**RESPONSES OF WINDHAM SOLAR, LLC
TO
CONNECTICUT SITING COUNCIL INTERROGATORIES - SET ONE**

On August 10th, 2020, the Connecticut Siting Council (“Council”) issued Interrogatories, Set One to Windham Solar, (“Petitioner”), relating to Petition No. 1359A. The Petitioner offers the following responses.

GRADING PLAN : BASIN #1

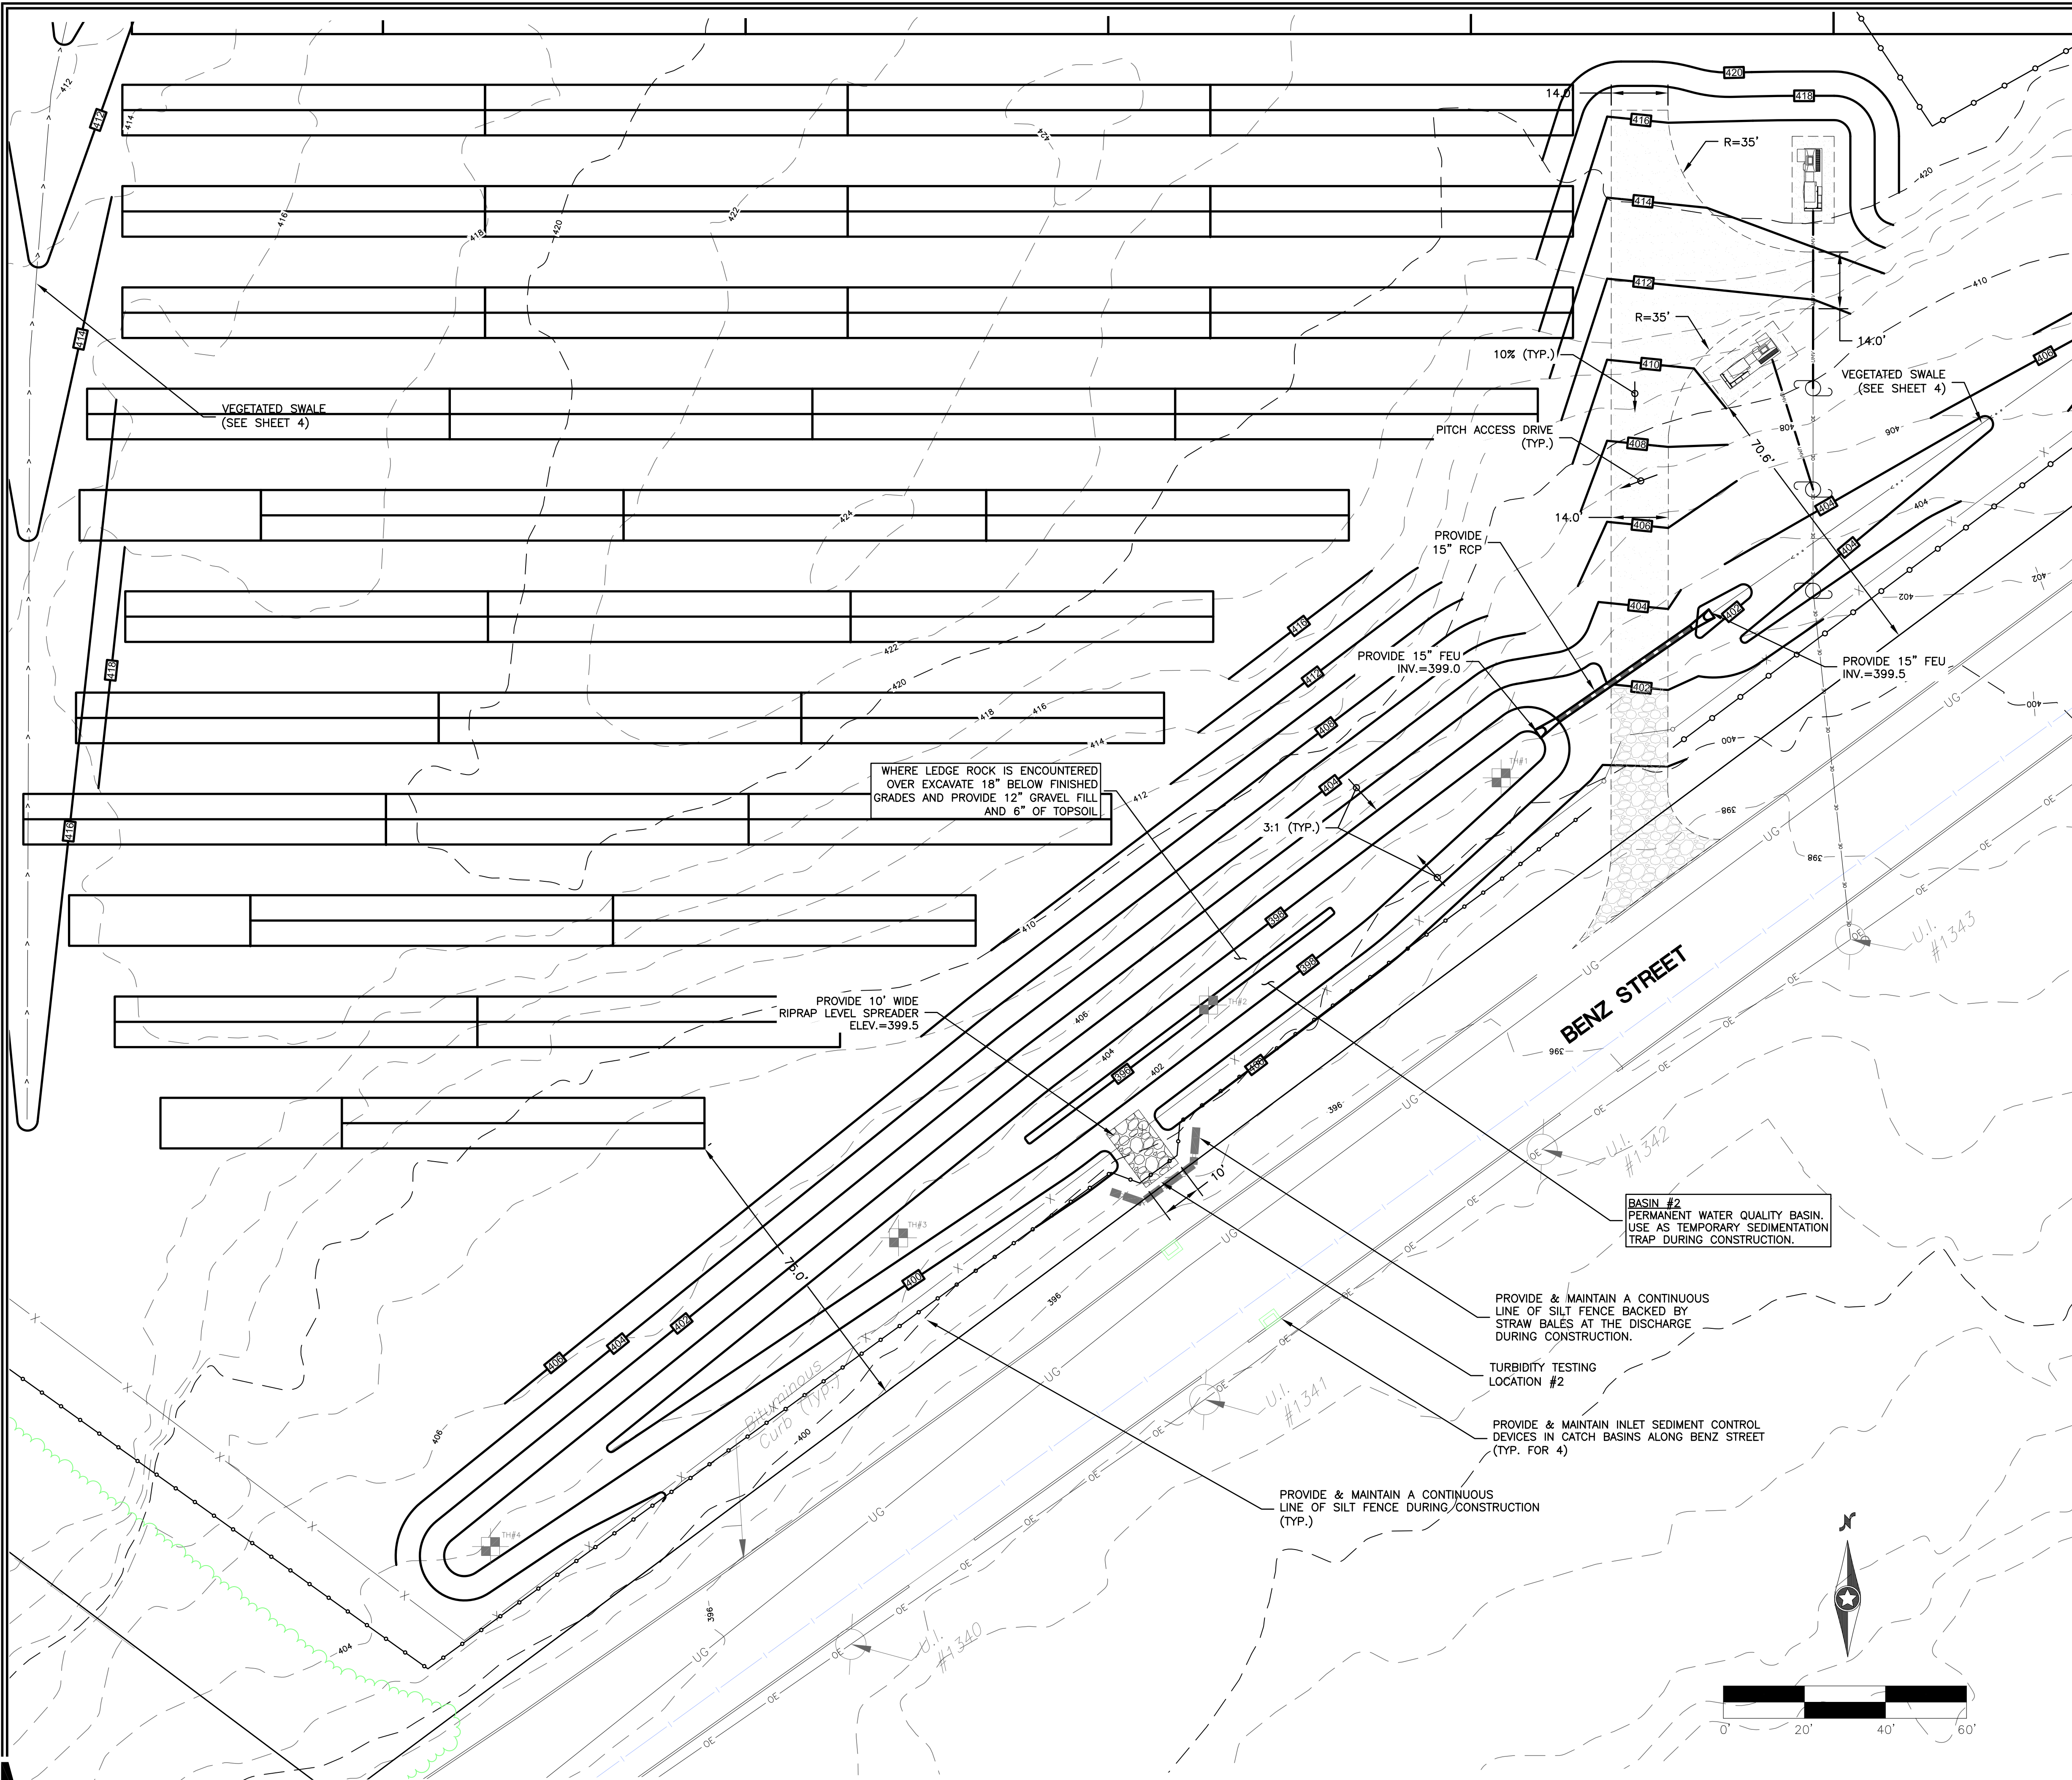
49. Why was a 50-foot wetland buffer included on the site plans?
What is the 50-foot buffer supposed to represent if the limit of construction is 12.1 feet from the wetland at its closest point, as indicated on Site Plan Sheet 5?

The 50' buffer was an incorrect representation on the plans. A 100' regulated area offset of the wetland has been illustrated in the revised plans. The basin has been redesigned based on geotechnical field tests, the vernal pool assessment and the additional stormwater requirements based on draft Appendix I. Grading for the basin will occur in the 100' regulated area.

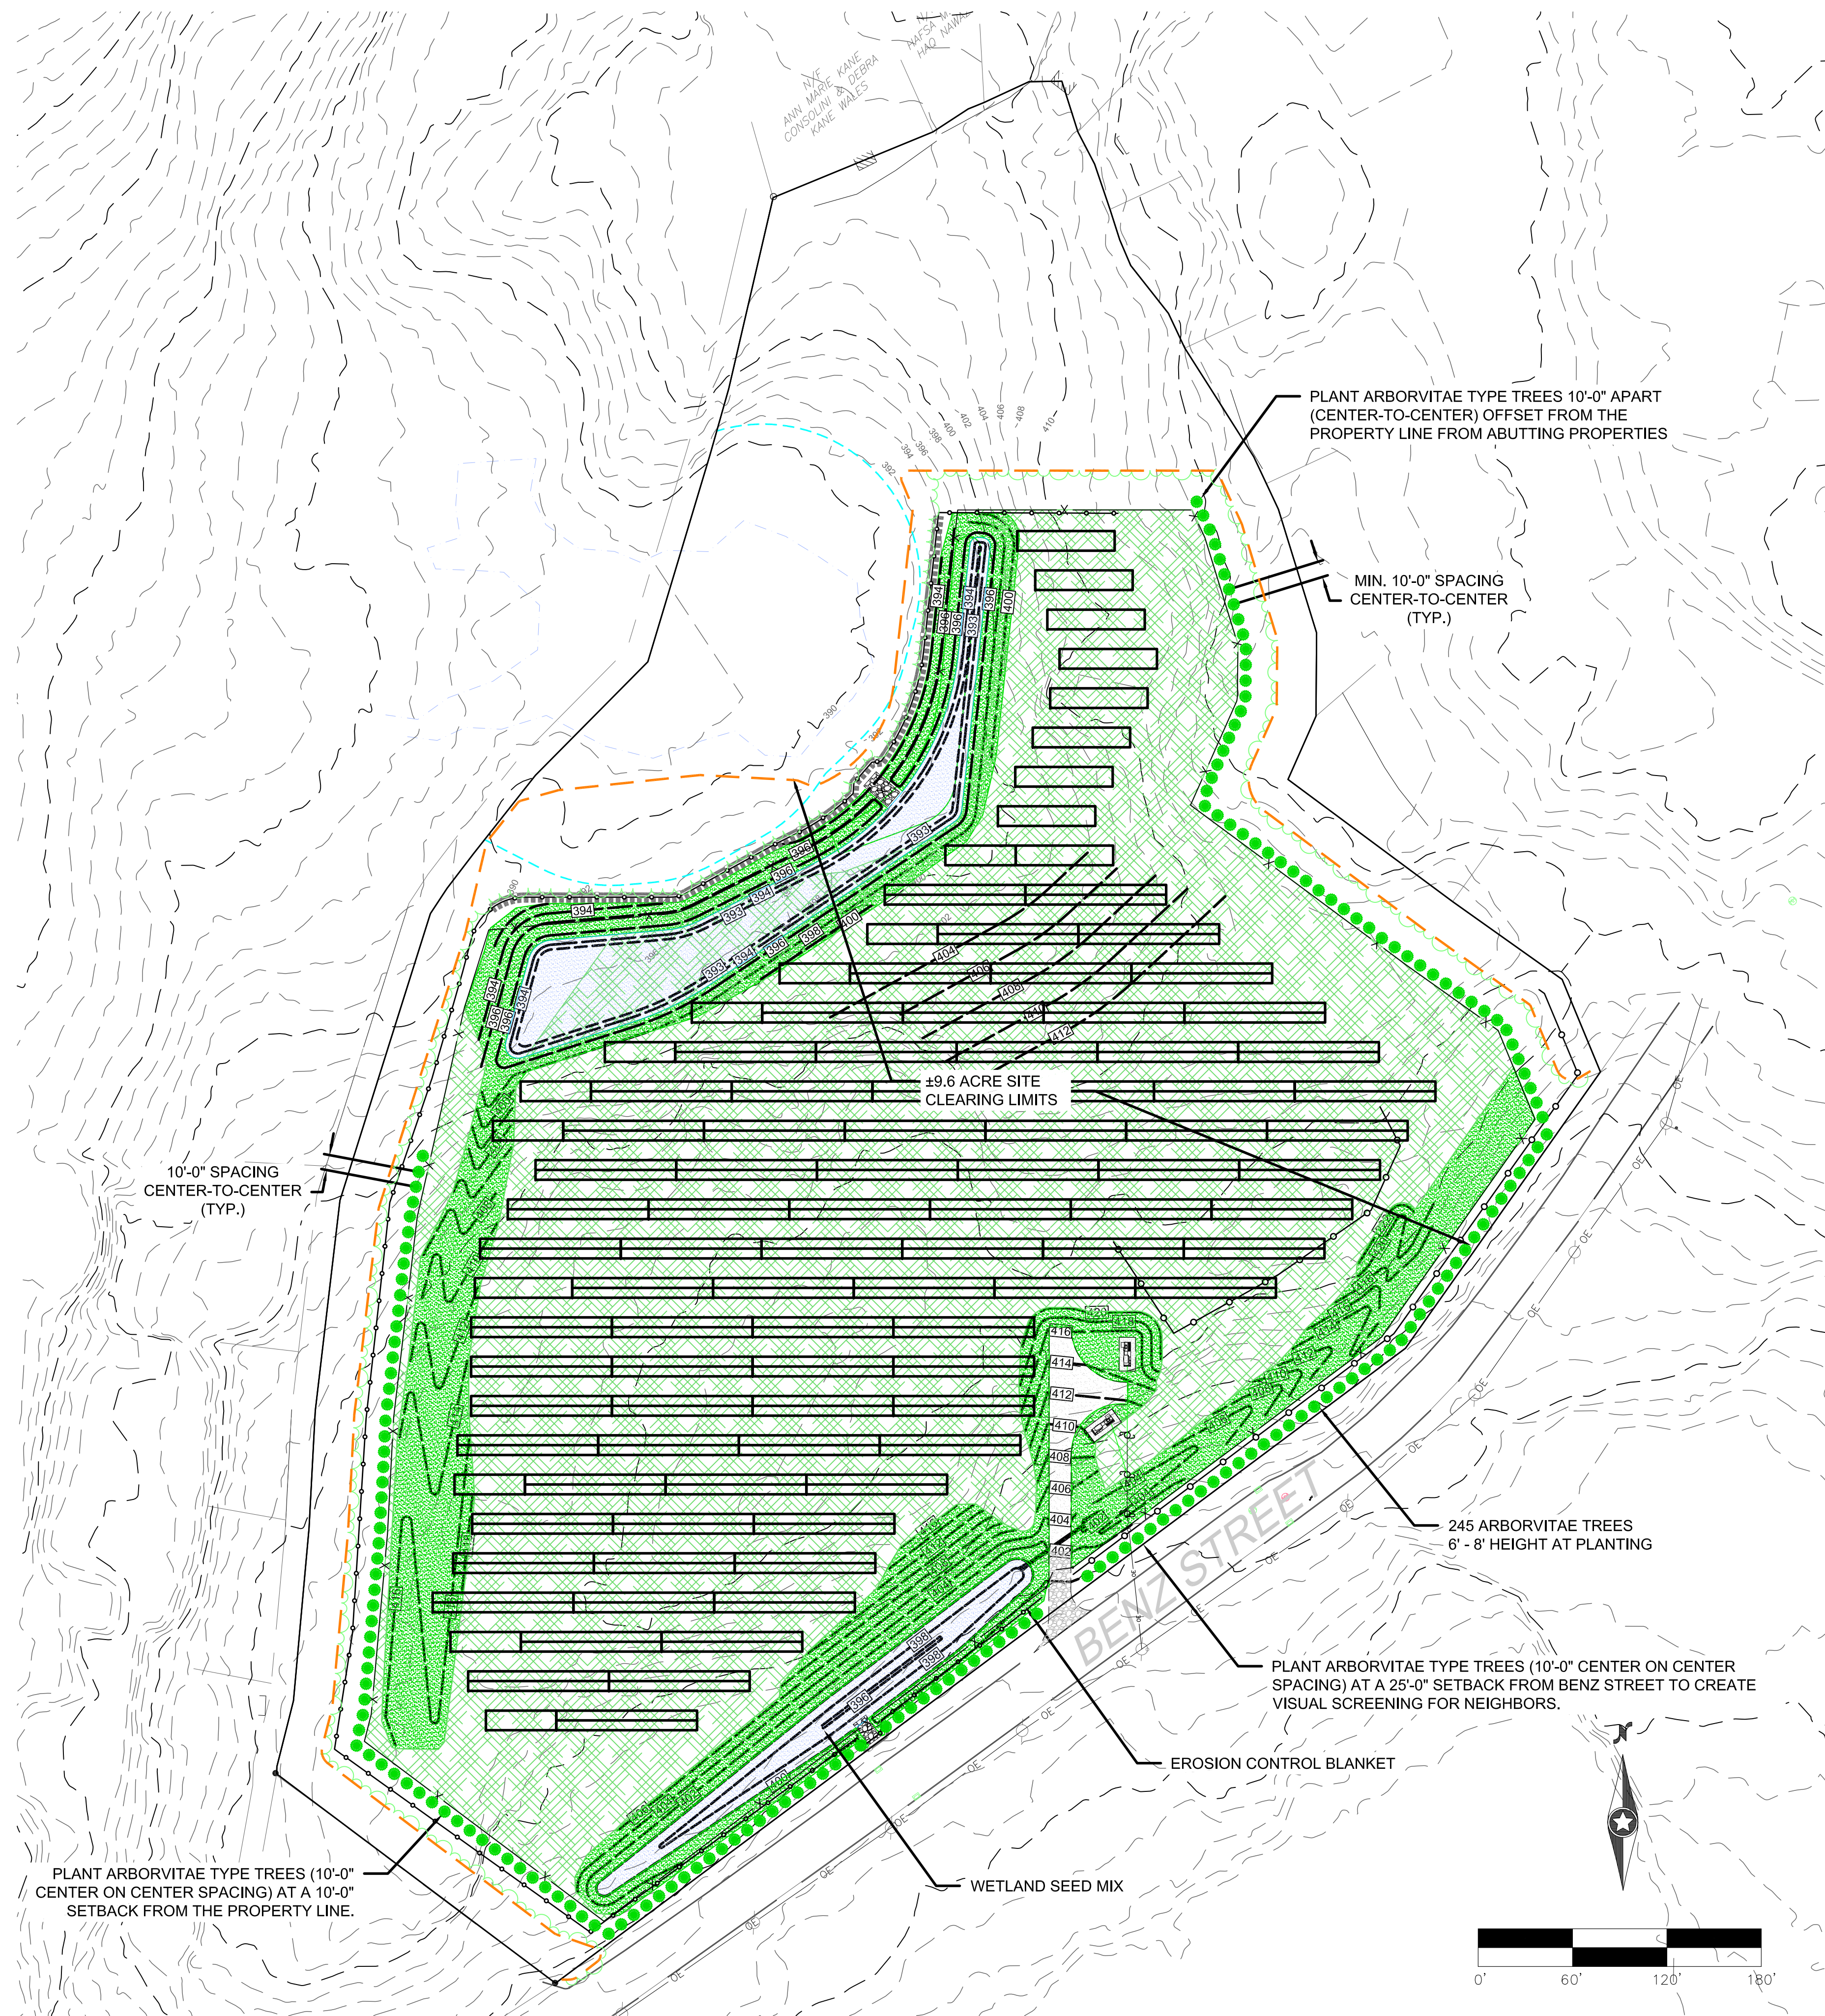
32. Referring to Site plan Sheet 6, where is the rip rap level spreader discharging to?
